**538 KARANGAHAPE ROAD, NEWTON: BUN60427502**

**S92 REQUEST RESPONSE TABLE**

**17<sup>th</sup> APRIL 2024**

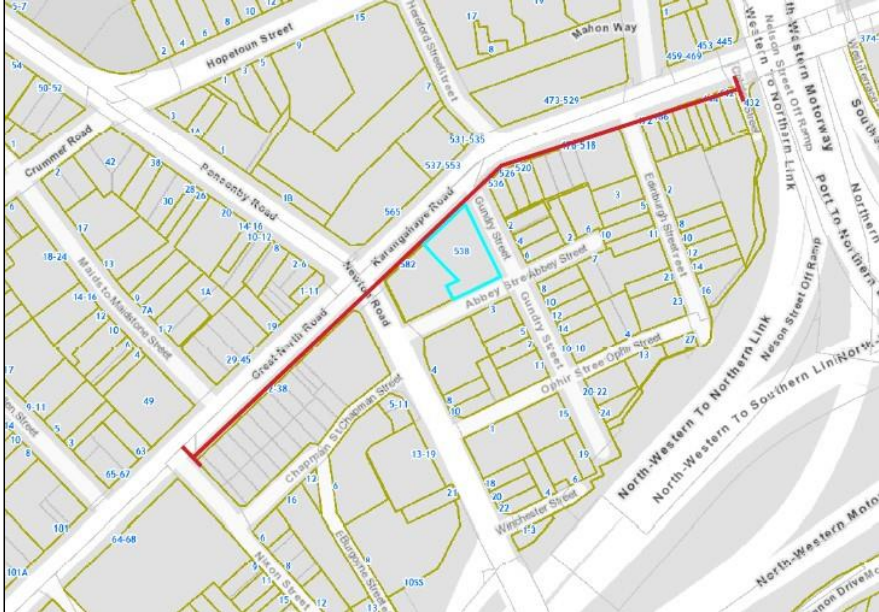
<p><i>The scale and type of species proposed will add visual interest to the respective façades which will assist with providing softening of the building.</i></p>	Variety	Grade (height at installation)	<i>Large Specimens</i>		<i>Ficus Ben</i>	2-3m	<i>Kentia Palm</i>	2-3m	<i>Small underplanting</i>		<i>Philodendron</i>	up to 300mm	<i>Aglaonema</i>	up to 300mm	<i>Zamioculcus</i>	up to 300mm	<i>Maranta</i>	up to 300mm
Variety	Grade (height at installation)																			
<i>Large Specimens</i>																				
<i>Ficus Ben</i>	2-3m																			
<i>Kentia Palm</i>	2-3m																			
<i>Small underplanting</i>																				
<i>Philodendron</i>	up to 300mm																			
<i>Aglaonema</i>	up to 300mm																			
<i>Zamioculcus</i>	up to 300mm																			
<i>Maranta</i>	up to 300mm																			
6.	Please advise if there is any likelihood for roof plant to be added. If so, provide some commentary on any potential visual effects arising, which may include additional height.	<p>An allowance has been made for roof plant as shown on plans, no other roof plant outside this zone is proposed.</p> <p>The roof plant is set back from exterior faces and is lower than saw tooth roof elements, within the plant platform so there is</p>

Request	Response / Action
		minimal visual impact from the street level. Refer to the images attached which show this area.
7.	At point 91 of the Landscape Visual Assessment the inclusion of an indicative building is discussed and shown on Fig 4, Viewpoint 1. Please explain why the same approach was not taken to include an indicative building on the site to the west of the application site from Fig 7, Viewpoint 02 and could you please include it on the additional Viewpoint 18.	<p>Isthmus state that:</p> <p><i>The indicative building on the adjacent property was included on Fig 4, Viewpoint 1 to help the reader understand the context of the site (compliant AUP building standards) and its localised urban setting. That particular site is currently vacant and the other adjacent sites already have buildings.</i></p> <p><i>For completeness, a series of new visual simulations have been prepared to illustrate indicative buildings on a number of the neighbouring properties (shown with red hatching). They have been modelled to illustrate the compliant building masses under the current AUP provisions and those planned under PC78.</i></p> <p><i>This assists with understanding the proposal in the context of the scale anticipated of future buildings in this central Auckland location.</i></p> <p><i>The new modelling included within the updated Appendix B to the 'Landscape and Visual Assessment' report includes the following:</i></p> <ul style="list-style-type: none"><li>• Existing panoramic photo,</li><li>• Proposed building,</li></ul>

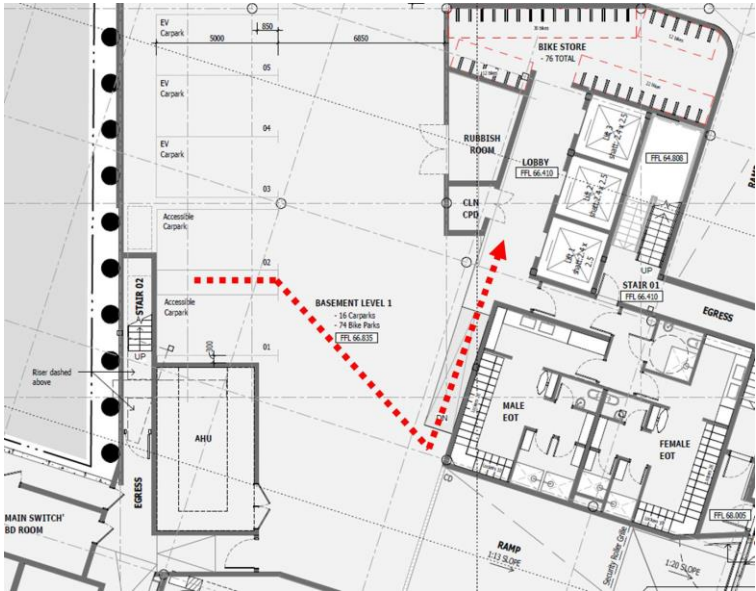
16.	<p>The TA refers to a waste vehicle servicing the building after typical operational hours and the Operational Waste Management Plan (OWMP) by Green Gorilla similarly refers to a service vehicle parking in the access lane. However, the specification of waste collection vehicle referred to in the OWMP has a height of 3.9 metres, while the TA refers to height clearances in the basement of between 2.1 metres and 2.5 metres. The AEE and OWMP state the waste vehicle may park in the vehicle access. Please confirm if the truck will be accessing the building / parking partially within the building. If the truck will be entering the building / parking partially within the building, please re confirm both the height of the vehicle and clearance within the part of the building to be accessed by a waste collection truck. If appropriate, please indicate if a shorter waste collection truck be used, and / or can vertical clearance within the building be increased.</p>	<p>Please see letter from Commute Transportation Consultants (CTC) which addresses this question.</p> <p>The rubbish truck is proposed to stop within the vehicle crossing and service the development from there.</p> <p>The collection times will be set outside operational / peak times.</p> <p>Vehicle tracking has been provided in Appendix A to the CTC letter to support this arrangement.</p>

Request	Response / Action
	Please also provide horizontal and vertical vehicle tracking to confirm the ability of a waste collection truck to access the site safely.

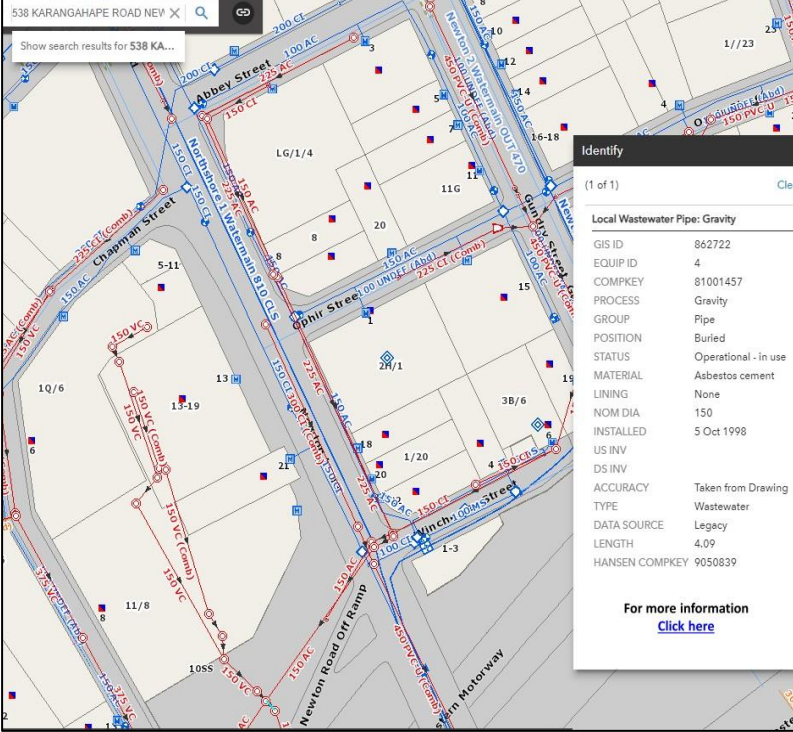
Request	Response / Action
<p>a. Please confirm if the car parking spaces proposed to be removed as a result of the new vehicle crossing will be reinstated.</p> <p>b.If these spaces will not be reinstated, please provide an assessment in accordance with Objective E27.2(3) Policy E27.3.3(f) of the effects of the loss of on-street parking arrangement on the western side of Gundry Street.</p> <p><i>Advice note: all four redundant vehicle crossings will need to be reinstated by the applicant to the kerb, channel and footpath. The No Stopping at Any Time line markings in front of the redundant Abbey Street vehicle crossings will need to be removed by the applicant. It is recommended that these reinstatement requirements are accepted as a condition of consent with the design detail considered at subsequent design stages. Anticipated required changes to the western side of Gundry Street (along the site's frontage) include:</i></p> <ul style="list-style-type: none"><li><i>•The removal of angled parking spaces to allow for the vehicle crossing,</i></li><li><i>•Reinstatement of both redundant vehicle crossings on Gundry Street,</i></li><li><i>•Provision of angled parking from the northern kerb buildout to the proposed vehicle crossing without adversely effecting visibility for vehicles leaving the site.</i></li></ul>	<p>The applicant agrees in principle with the reinstatement and is happy to discuss and revise the CTC concept design in line with Auckland Transport requirements.</p>

Request	Response / Action
<p><i>•It is likely that the applicant is requested to remove the existing motorbike parking bay.</i></p> <p><i>The image below illustrates a concept of how the reconfiguration could work, with the green bar indicating AT's preferred space for paid angled parking. Please note this figure is for reference only to guide a design by the applicant, and it does not indicate that a similar design will be approved in future.</i></p>  <p>The image is an aerial photograph of a street intersection. A large building with a grey roof is on the left. The street is labeled 'Karangahape Rd' at the top left, 'Dunmore St' in the middle, and 'Abbey St' at the bottom. A green rectangular area is highlighted along the side of the road, indicating a preferred space for paid angled parking. A red oval highlights a specific area, likely the existing motorbike parking bay mentioned in the text. A yellow line indicates a path or boundary near the intersection.</p>
